Access Compliance Report

Public Rights-of-Way

(Curb Ramps)

| Intersection ID: 51510 | Main Street: KENILWORTH_AV | Cross Street: PEARL_PARK_WY | Location: NW |

| ADA ID: 2797A456E6E5 | Ramp Type: Perp | Initial Pass/Fail: Fail | Overall Compliance: No |

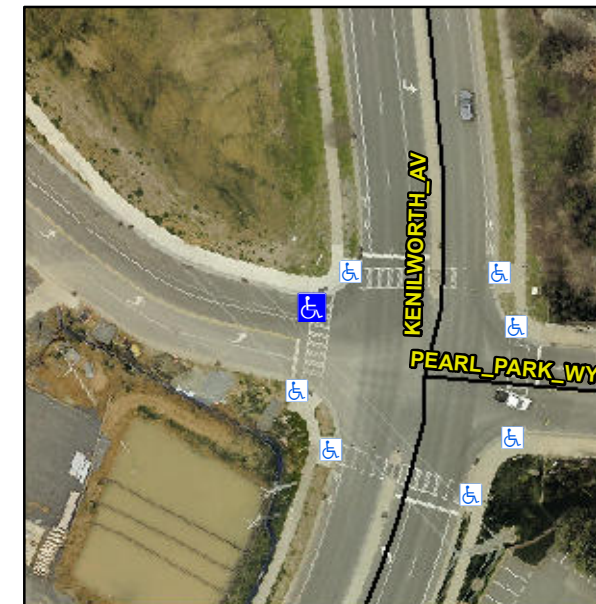
Not Found, R304.2.2, R304.5.3

| Compliance | Description | Data | Compliance | Description | Data |
|------------|-----------------------|-------|------------|-----------------------------|------|
| N/A | Ramp Length (in) | 93.0 | No | Ramp Slope (%) | 9.1 |
| Yes | Ramp Width (in) | 59.0 | No | Ramp XSlope (%) | 5.0 |

Remove & Replace Entire Ramp.
